**Re: Monterey Bay Shore Ecoresort Project
A-3-SNC-98-114-EDD (Security National Guaranty, Inc.)**

Hearing: Dispute Resolution (Condition Compliance), May 15, 2015

[illegible]

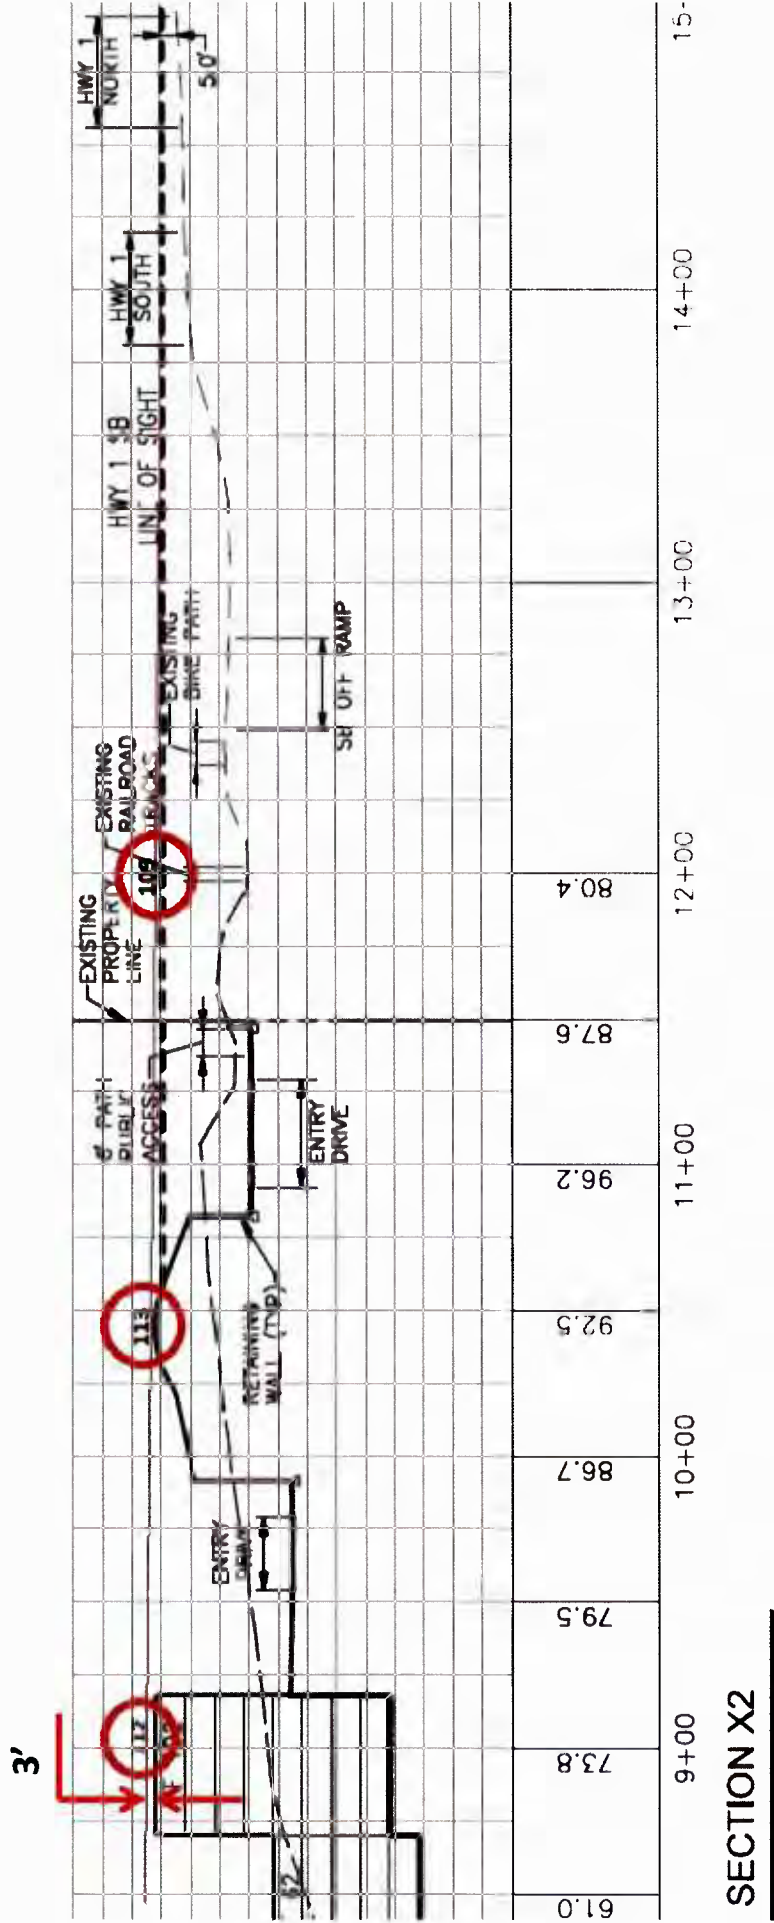
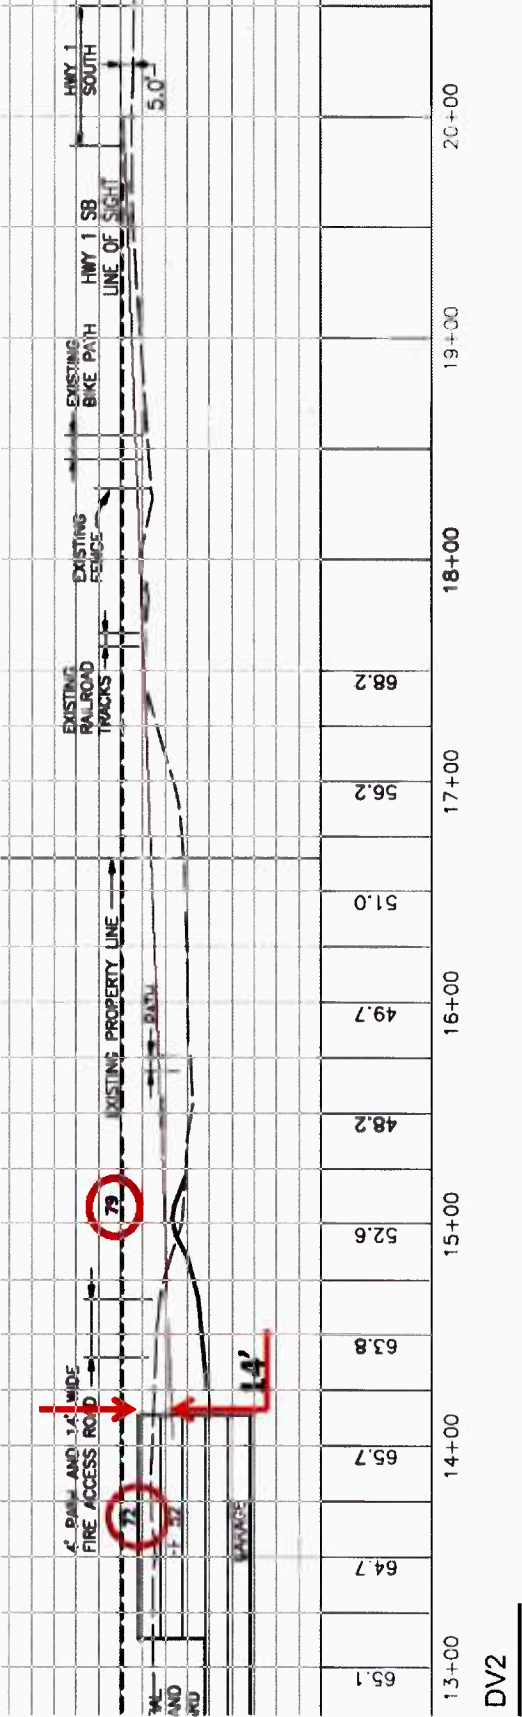
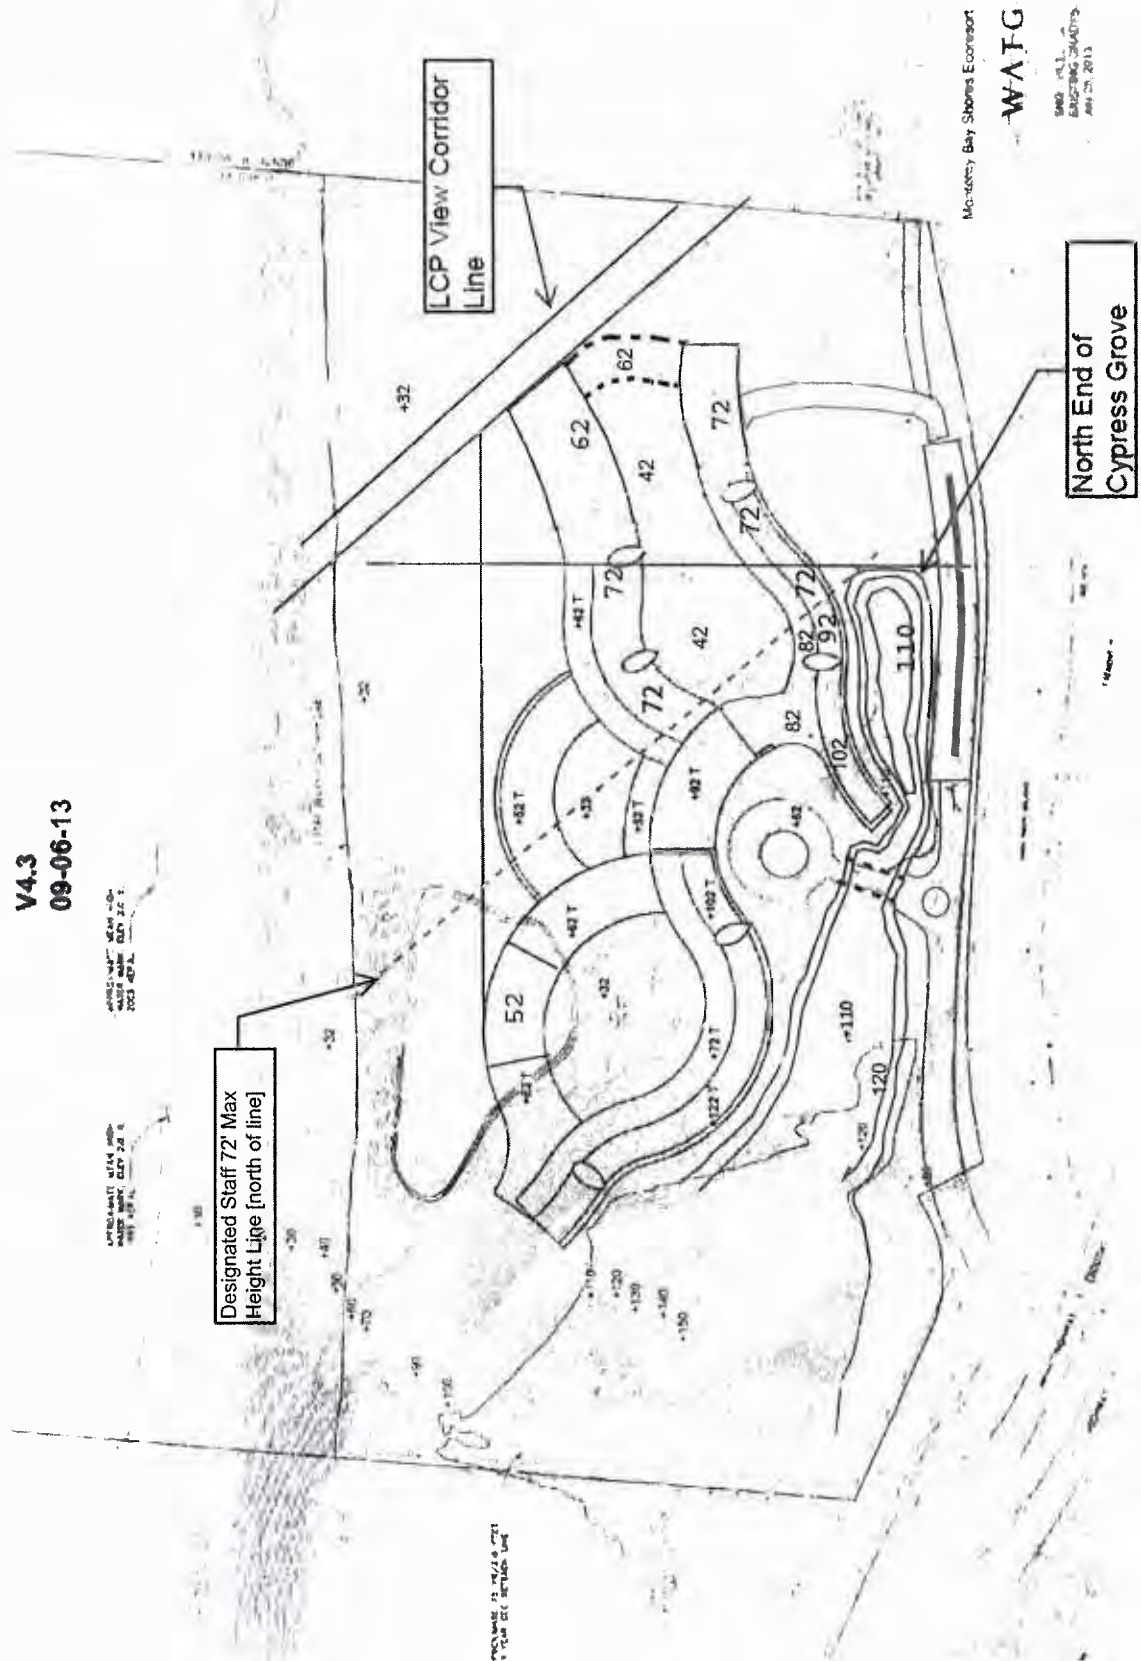
Project Plans Comply With “Building” View Requirements. The Revised Plans, extensive cross-sections across the Highway One frontage (no less than 13, plus 6 on the north end of the property – see the “master” cross-sections plan sheet which accompanies this letter as **Exhibit 9**), and Auto-CAD view simulations that SNG agreed to provide following its September 10, 2014 meeting with staff fully comply with the Settlement Agreement and Special Conditions 1 and 1(b). Nothing more is required.

For the first time, Staff now states that portions of buildings near the main resort tunnel also will be visible in the northbound Highway One view and those portions of the hotel and a portion of the residential building will be visible from Highway One views. The Staff Report again does not provide any indication of the locations that staff has in mind, but, importantly, all of the buildings are exactly at the heights agreed to in the Settlement Agreement and as shown on the approved VTM. Again, there is no deviation. Further, with one exception – well known to the Commission and fully discussed at the April 2014 hearing, none of the cross-sections that staff requested supports its claim.

SNG's Submission of Precise Site Plans, Cross-Sections, and Auto-Cad Renderings. Staff additionally argues that "architectural elevations" should also have been provided, beyond the extensive cross-sections (19 in number) and Auto-CAD view simulations submitted, which Staff agreed in a meeting with SNG on September 10, 2014 were the only deliverables necessary. The staff report is correct when it states that SNG has refused to expend yet more time and money in condition compliance to generate architectural elevations that are of no added value on the Highway One view issue.

Moreover, in this case SNG has provided 13 cross-sections to demonstrate the relation of Highway One to the restored dunes and the buildings. The cross-sections are engineering-wise absolutely precise. They are spaced across the Highway One frontage at varying intervals of approximately 90' (upcoast) and 50' (downcoast), and the Auto-Cad computer renderings are likewise precise engineering drawings in 3D and show the property from 5' above the Highway at a proper distance from the site. The building heights are accurate and conform to the approved heights in the Settlement Agreement, the VTM, and Special Condition 1 (introductory paragraph). The dune heights are plainly reflected on the VTM. The cross-sections and additionally the Auto-Cad view simulations are precise and accurate. The repeated assertion in the Staff Report that staff is hampered because SNG has not provided architectural renderings of all "four sides" of the Project argues for a useless exercise in terms of analyzing post-Commission approval the Project's compliance with Special Condition 1.

One further point bears emphasis. The Auto-Cad views were requested by staff, but despite the "reality" that staff seems to want, it told SNG to remove anything between the Highway One and the development area. So, what the Commission sees in the Auto-Cad view is not what one sees, in reality. It is what one sees only if the area is swept clean of any view obstructions in the foreground. To give the Commission a better sense of reality, SNG provides a "Z" cross-section and cross-section of the Dune View Line, each followed by the Auto-Cad view and then the view with the existing Cypress trees, vegetation, light standards, freeway signage and railroad tracks in the foreground off the property. These accompany this letter collectively as **Exhibit 13**.

EXHIBIT 13 - Z CROSS SECTION

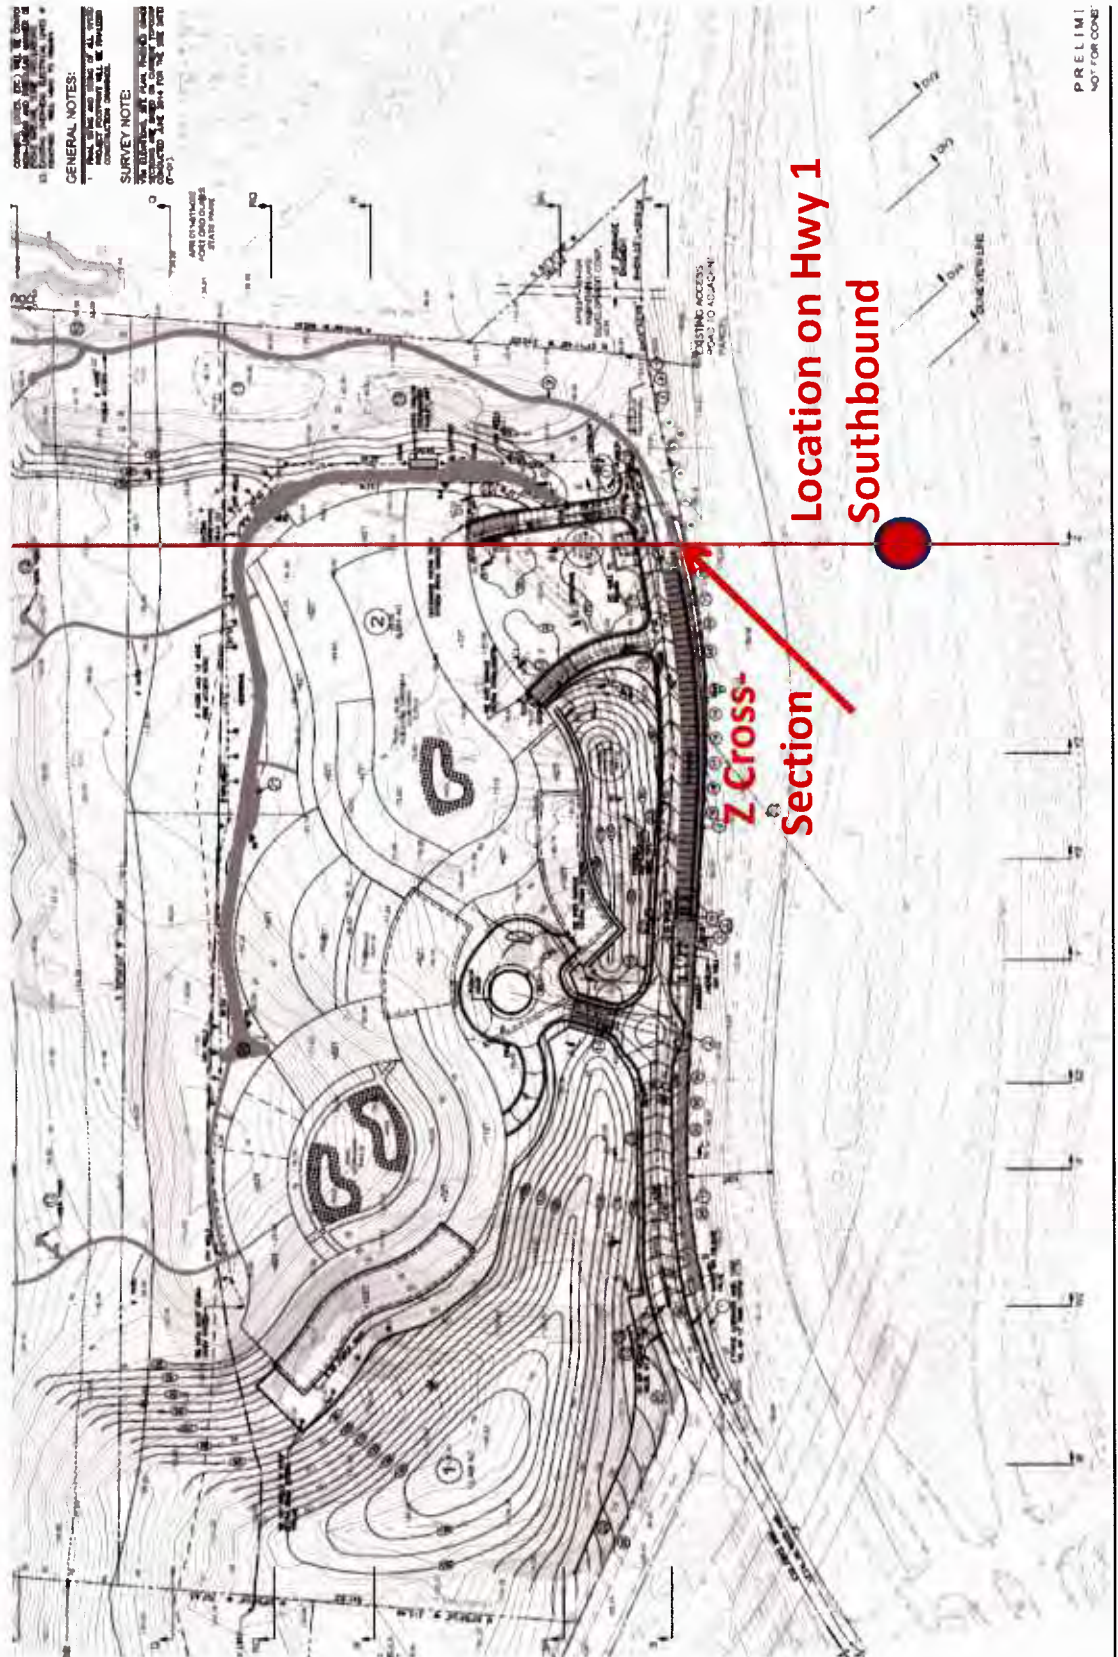
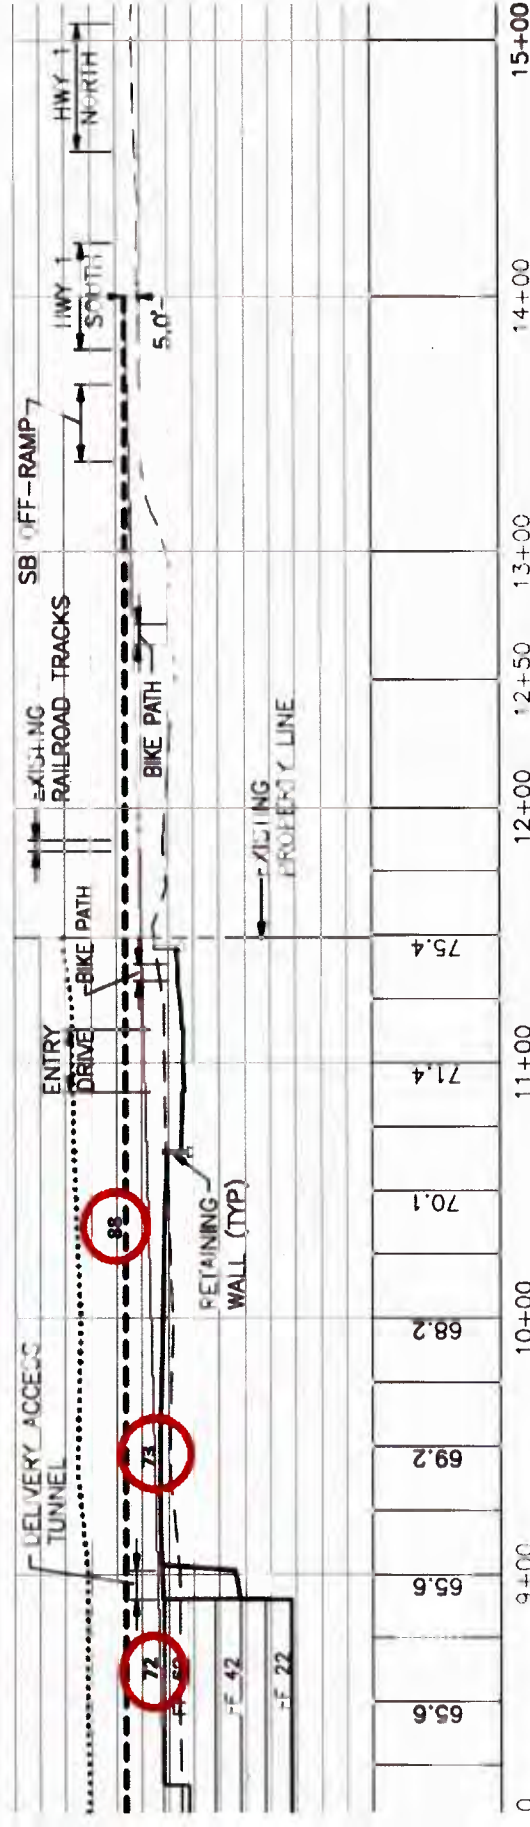
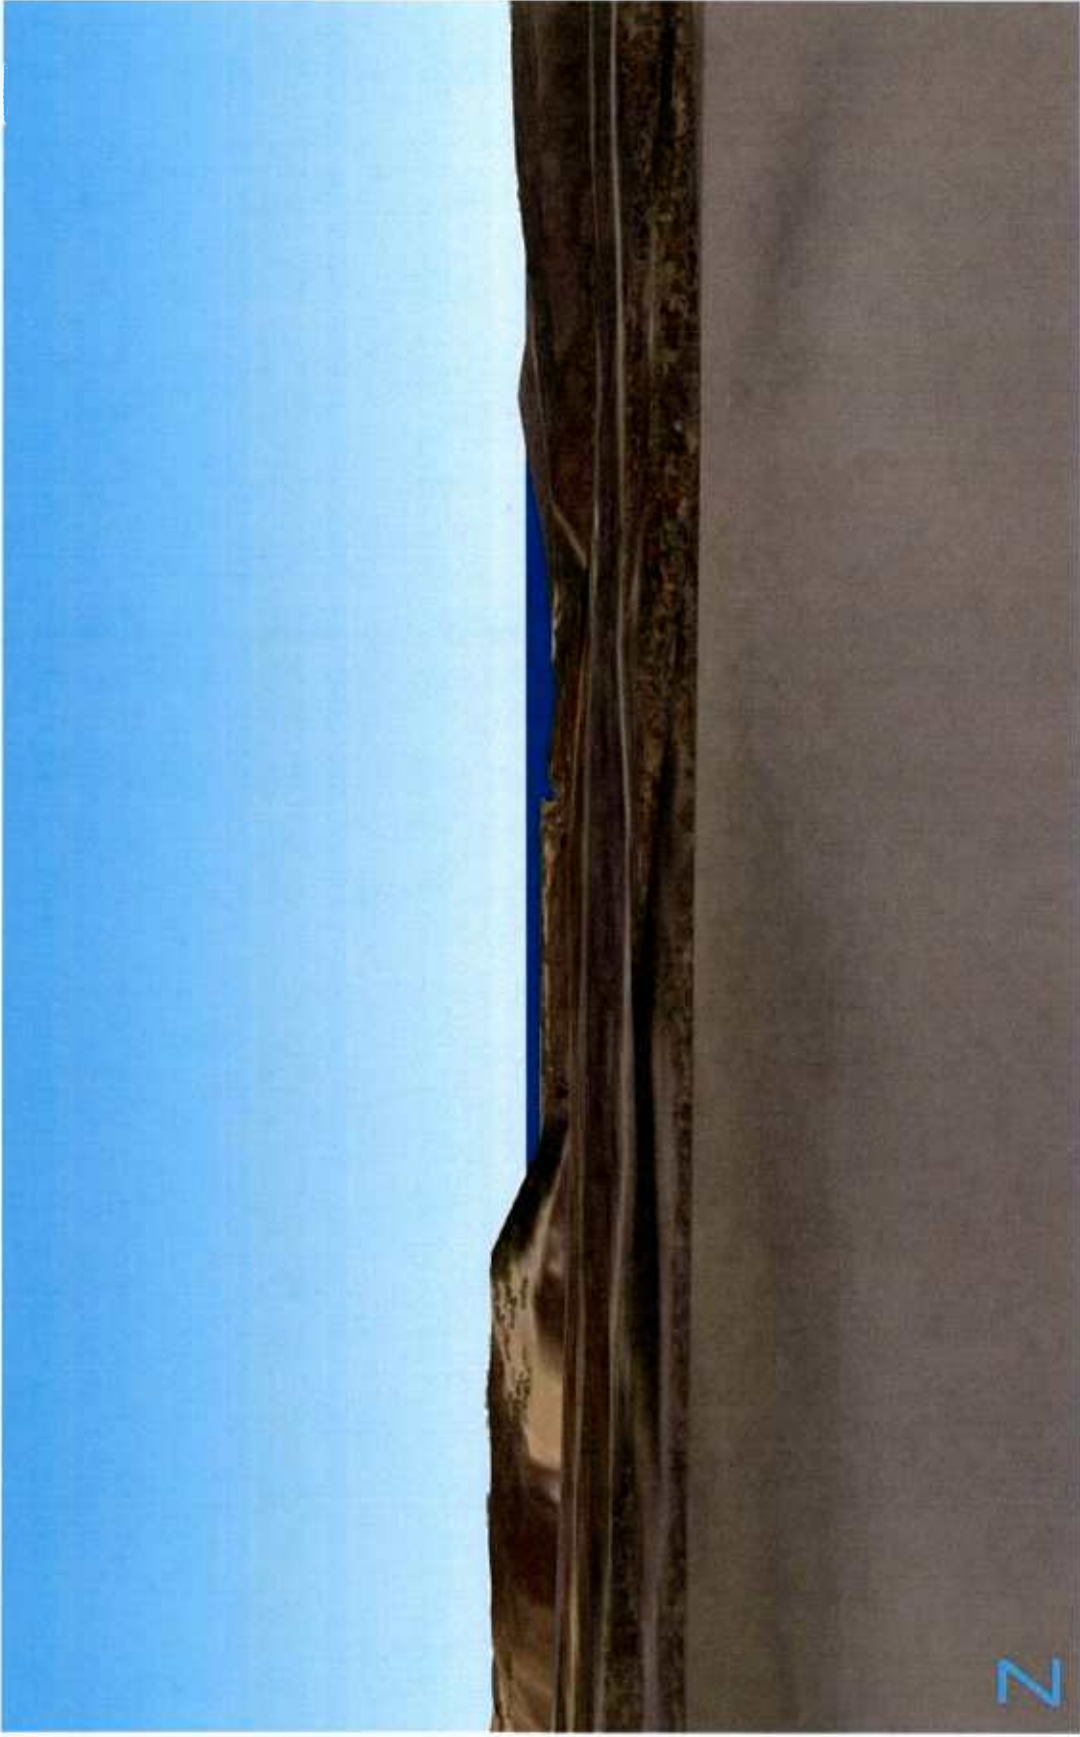
The Staff Report (at page 9) asserts that dune manipulation in aid of screening structures "will lead to its own additional view blockage." This is, frankly, nonsense. Special Condition 1(a) permits "dune field manipulation north of the extended dune for screening purposes" and Special Condition 1(b) provides that the buildings be sited and designed so that they are blocked by existing and/or "modified dune features." Clearly, dune screening of structures is expressly permitted, but nothing in the Revised Plans submitted to comply with Special Condition 1 creates any "additional view blockage," and the Staff Report does not and cannot identify any such instance. In fact, in a number of instances the blue water view is enhanced.
